Serial No. 10/707,567  
Filed: December 22, 2003  
Page 5 of 10

**Amendments to the Drawings:**

### **REMARKS/ARGUMENTS**

Fig. 12

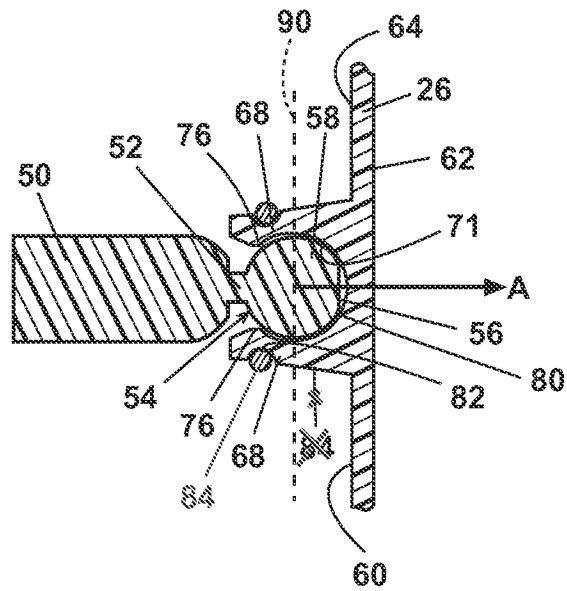
The Examiner asserts that element 84, shown in Figure 12, does not properly point to the compression spring. Figure 12 has been amended so that element 84 points to the compression spring.

Fig. 16

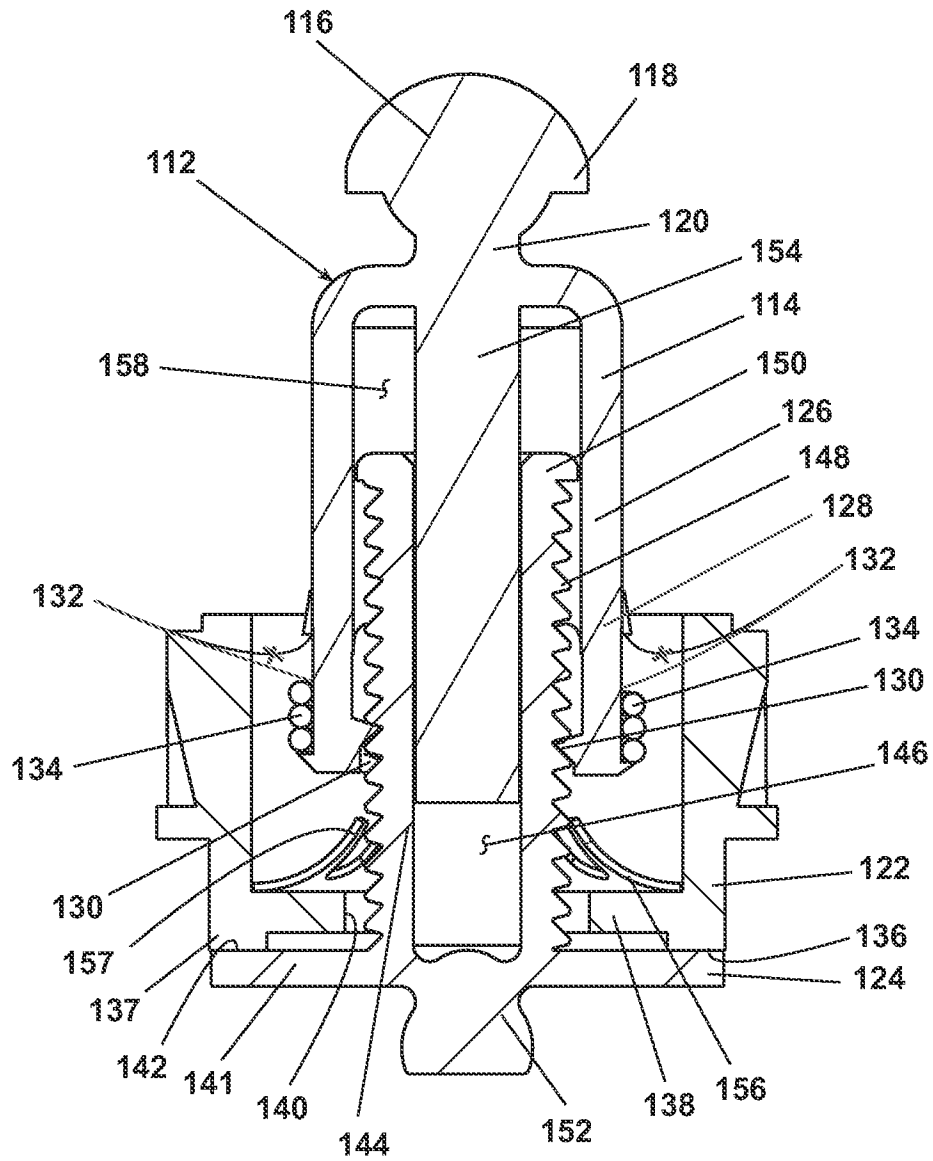
The Examiner asserts that element 128 shown in Figure 16 fails to include a lead line. Figure 16 has been amended to show a lead line from element 128 to the appropriate structural element.

The Examiner asserts that element 132 shown in Figure 16 does not properly point to the spring channel. The lead lines from element 132 have been redrawn in Figure 16 to more clearly point to the spring channel.

Fig. 18

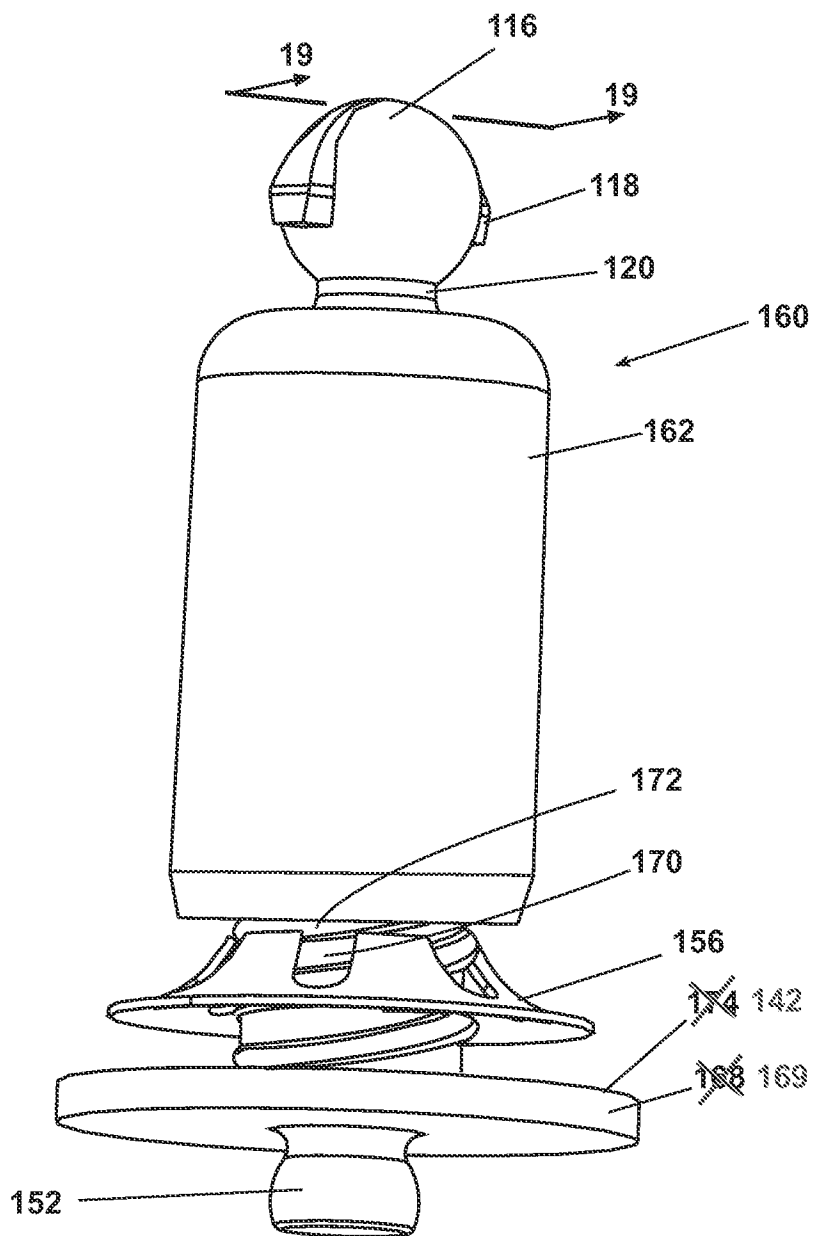
The Examiner asserts that reference numeral 174, shown in Figure 18, lacks a proper written description. Figure 18 has been amended to change reference numeral 174 to reference numeral 142, which has a proper written description. Moreover, reference numeral 168 has been changed to reference numeral 169 to correct a typographic error.
